Number	Description
1	Revised or Added Plan Sheet Nos. 8001, 8016, 8037, 8069, 8070, & 8071; Amendment EBS Download Required.

BR-0018-02(052) / 103325301

Attala County(ies)

ADDENDUM

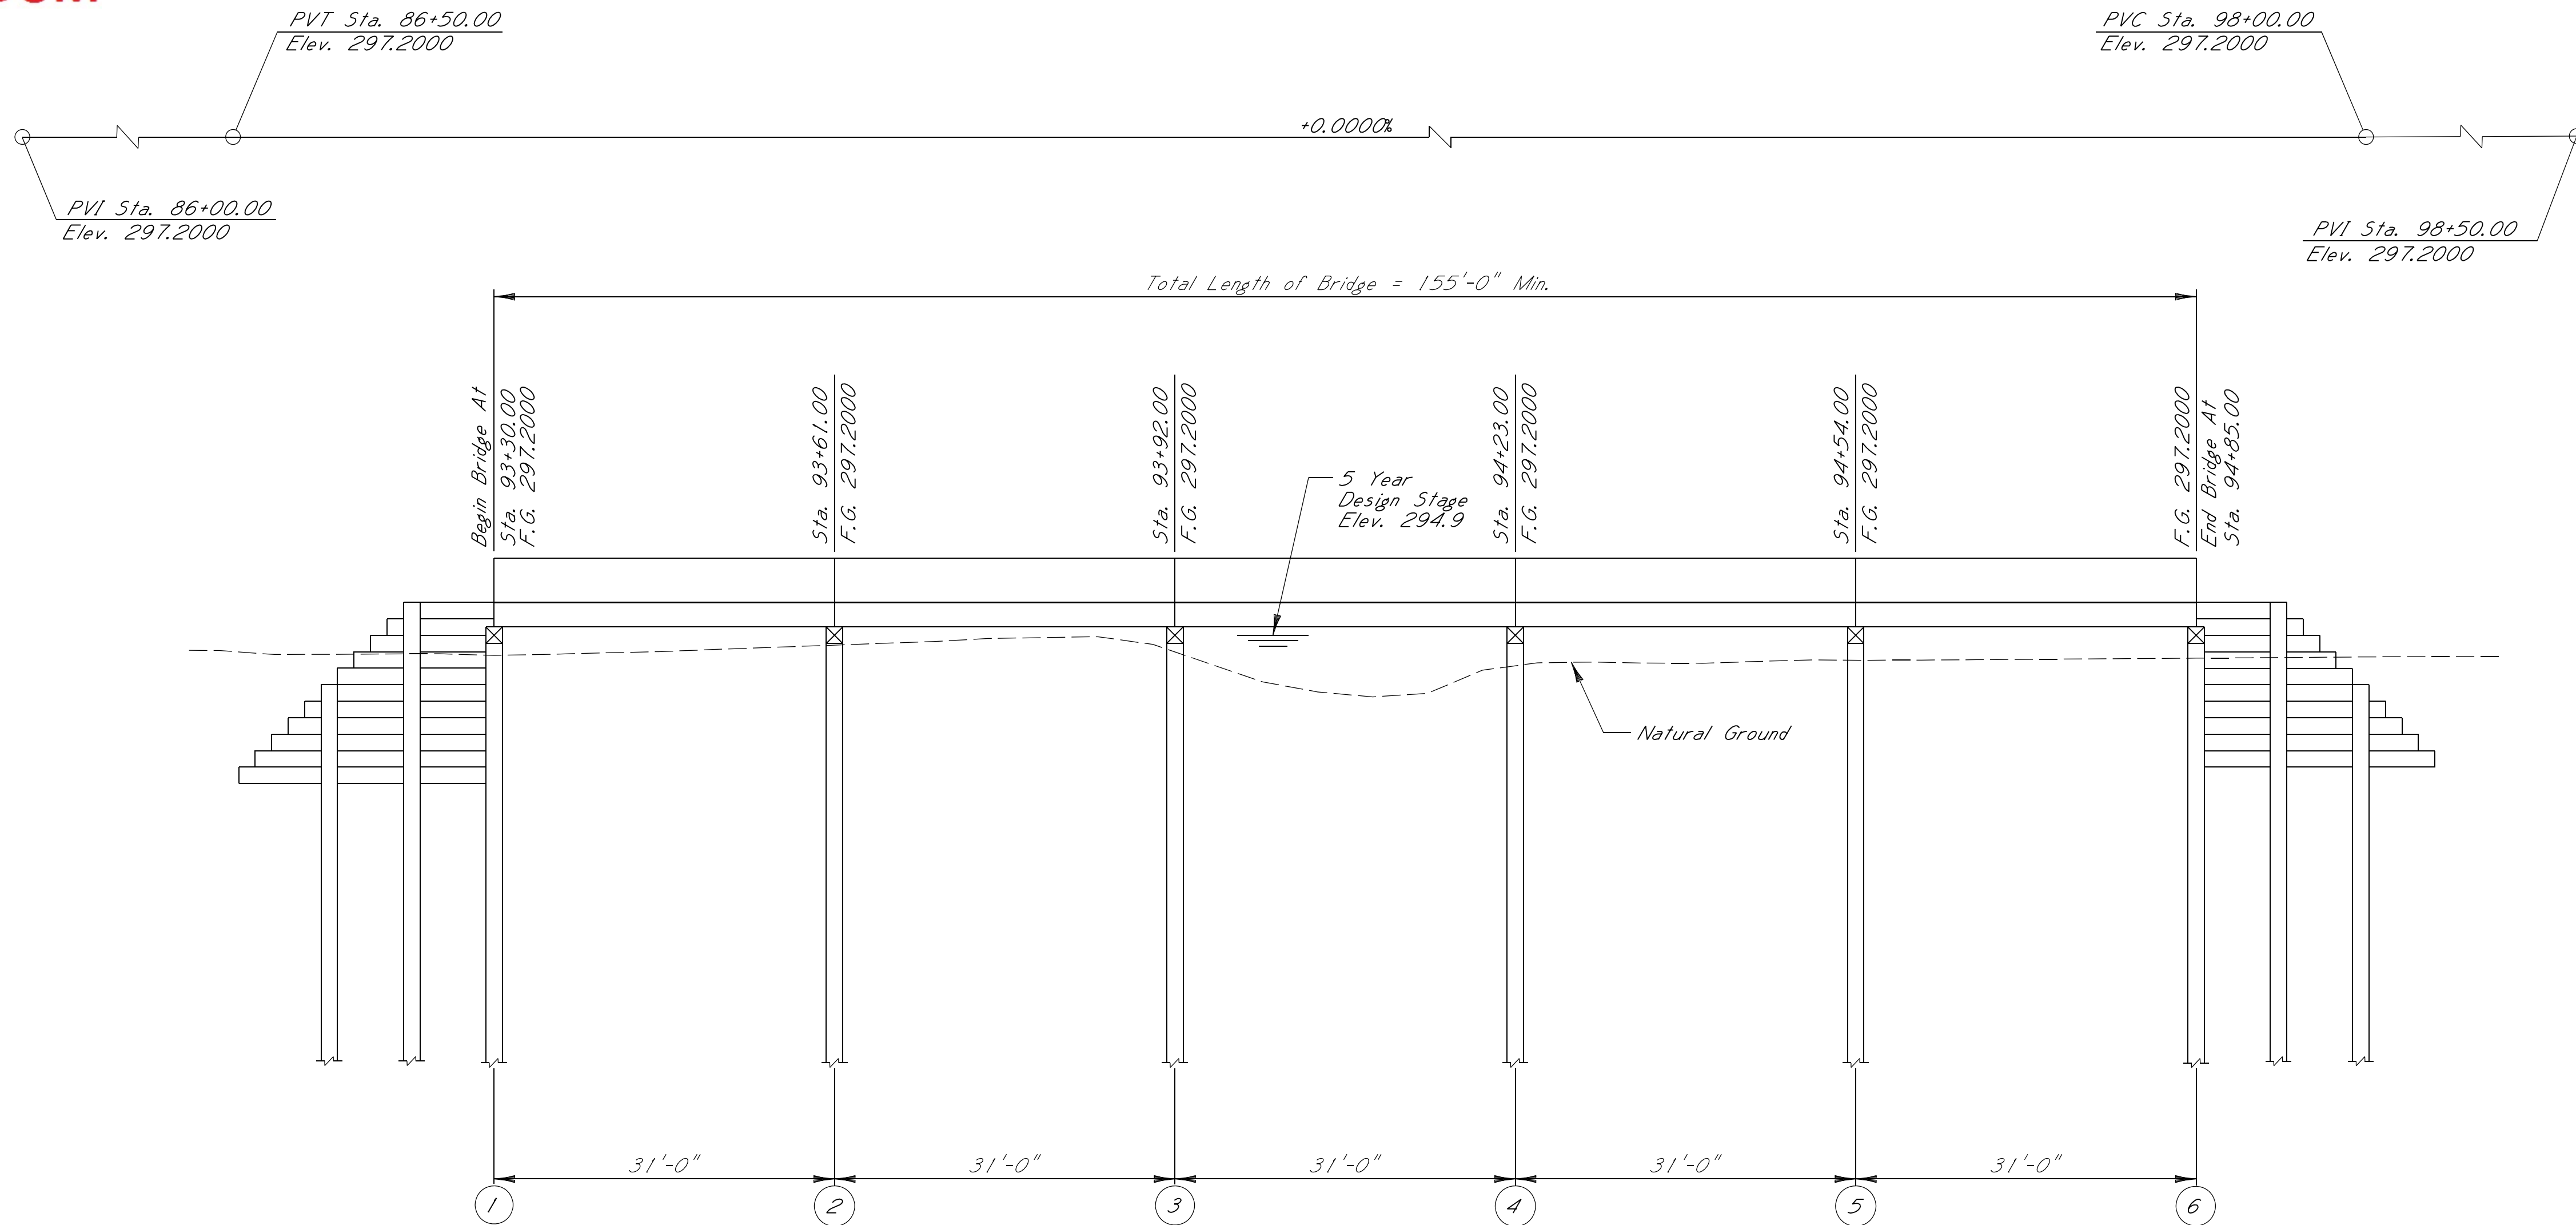
NOTE TO CONTRACTOR:

The Contractor shall employ the service of a registered Professional Engineer who is knowledgeable and proficient in the field of bridge design.

The Contractor's Design Engineer shall determine the required ultimate pile bearing capacities based on the use of Pile Dynamic Analysis (PDA) for the condition/bearing resistance determination method per the AASHTO LRFD Bridge Design Specifications.

The Contractor's Design Engineer will be responsible for providing the Pile Dynamic Analysis (PDA) and for establishing the production pile driving criteria.

The Contractor's Design Engineer shall determine the lengths of all test piles and production piles.

The following exceptions to the AASHTO LRFD Bridge Design Specifications will be allowed for the design of Detour Bridges:

- (1) The design of the substructure of the Detour Bridge shall be made to satisfy the requirements of the following Limit States: Strength I, Strength III, Strength V, and Service I.
- (2) With PDA pile tests for the Detour Bridge Piling being performed and analyzed by the Contractor's Design Engineer, a value of 0.85 for the condition/resistance Factor for Driven Piles may be used to set final Detour Bridge pile lengths.
- (3) The Design Vehicular Loading (Truck + Lane) used may be 75% of the HL-93 Live Loading.
